Appl. No. 10/724,570
Amdt. Dated July 20, 2006
Reply to Office Action of July 20, 2006

Amendments to the Drawings:

Remarks:

FIG. 8 PRIOR ART

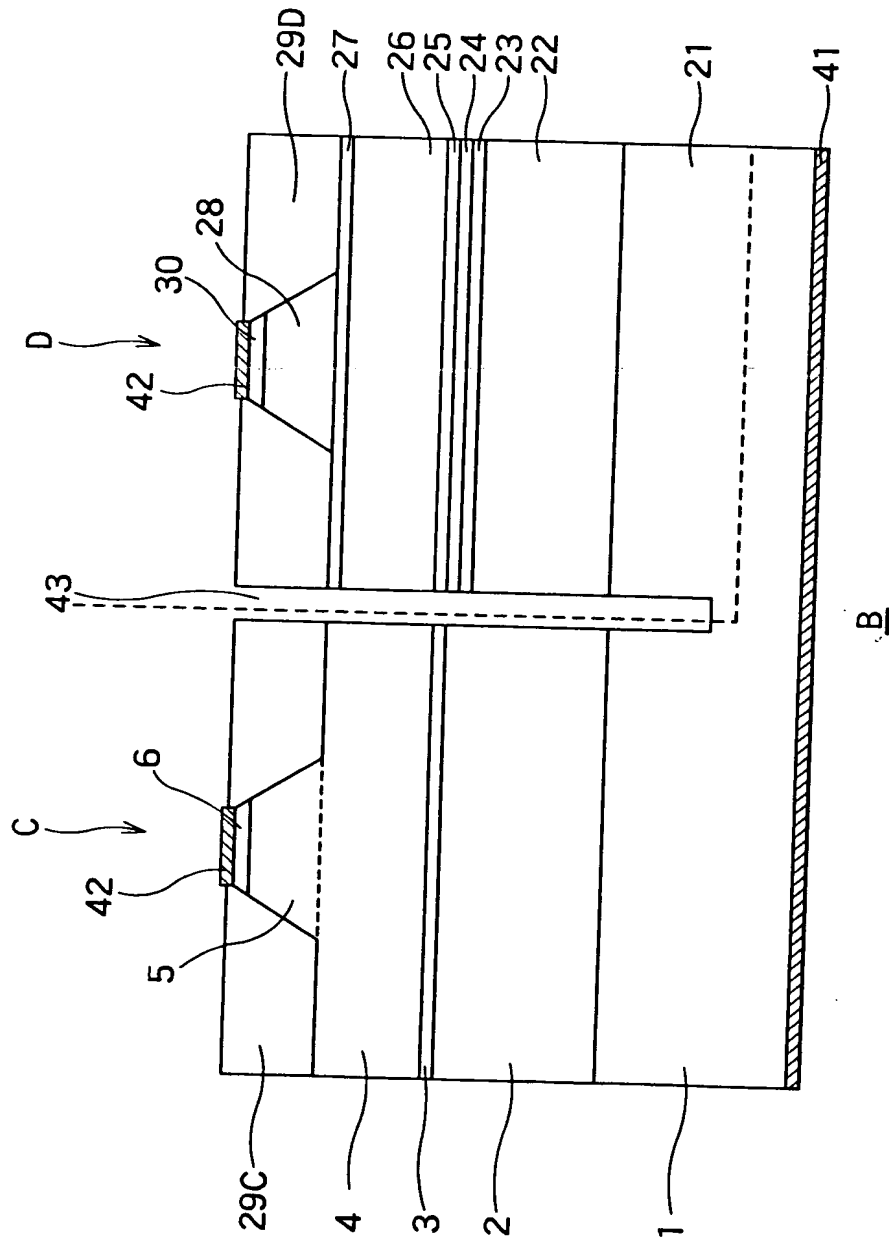
The attached sheet of drawings includes changes to FIG. 8. This sheet, which includes FIG. 8, replaces the original sheet including FIG. 8. Applicant adds the label "Prior Art" to FIG. 8.

The Office Action required an amendment to the drawings. Applicant amends the drawings according to the Office Action's instructions.
